# OFFICE OF THE MAYOR

## **Darbrook Coal Mine - Modification 7 (DA231-7-2000 MOD7)**

I write, on behalf of the Upper Hunter Shire Council, with reference to the Department of Planning & Environment's [DPE's] letter of June 4th, providing additional information regarding the Darbrook Coal Mine Modification 7 Development Application. We would be grateful if you would forward this correspondence to Commissioners Lipman, Carter and Cochrane who are considering this proposal.

### 8.1.22 Dartbrook 2005

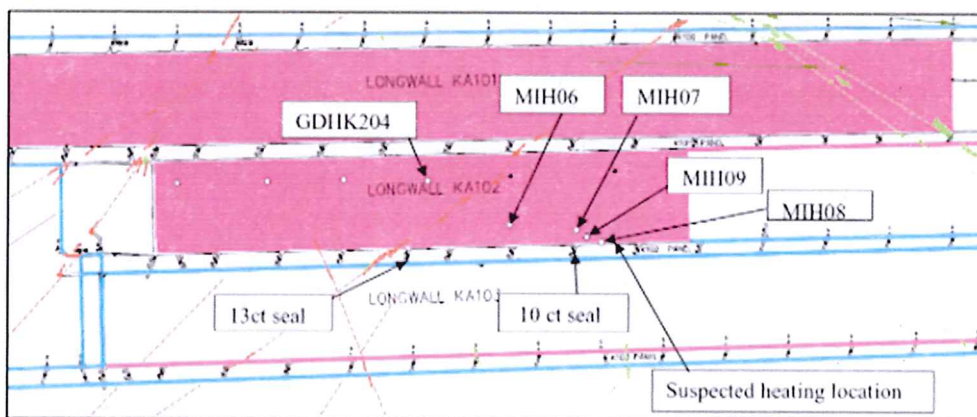
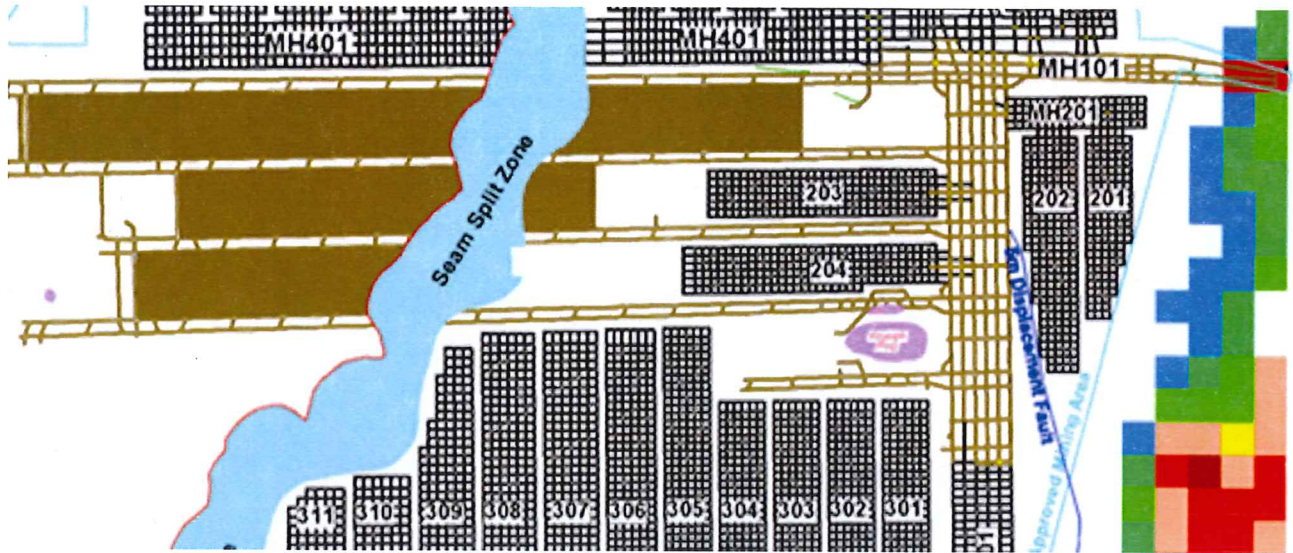
- In their response the Resources Regulator states it is *“unaware of any spontaneous combustion issues relating to extraction in the Kayuga seam at Dartbrook”*. Frankly, this beggars belief. The NSW Government’s own Guidelines, specifically MDG 1006 - Technical Reference Spontaneous Combustion Management, produced by the Mine Safety Operations Branch of Industry and Investment NSW May 2011 details two such incidents in the Kayuga Seam at Dartbrook. Link is <http://cb3mineservices.com/wp-content/uploads/2014/08/MDG-1006-TR.pdf> extracts copied below.

- However, the Regulator goes on to tell us that *“There is no relationship between “gas” levels and the likelihood of spontaneous combustion”*. In other words whether the “gas” levels are high or low is not relevant to whether the Kayuga seam is prone to spontaneous combustion. Maybe the Kayuga seam’s demonstrated history - the one the Regulator is seemingly

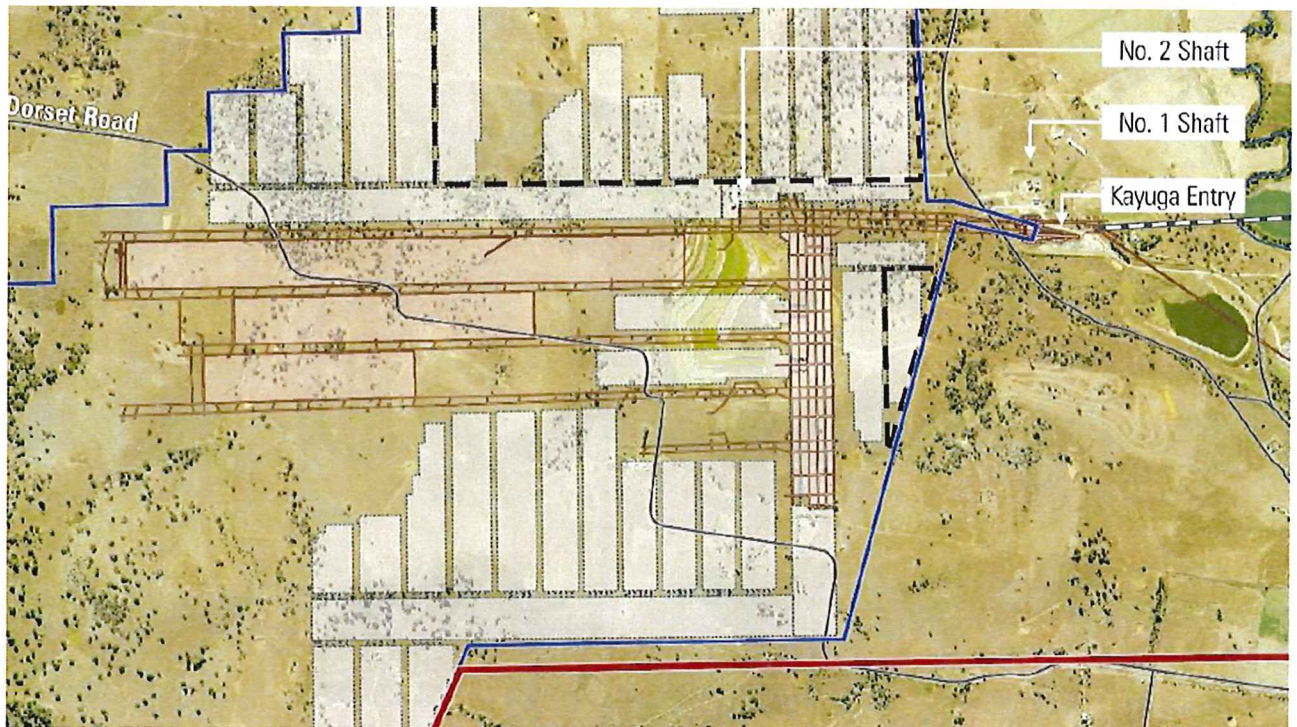
unaware of despite it being documented in its own literature - just might be? It can be seen from the proponent's documentation (reproduced below) that they are planning to mine in exceedingly close proximity to the previous heating incidents. Panels 203, 204, 305, 306, 307 and 308 are adjacent to former longwall panel ka102.
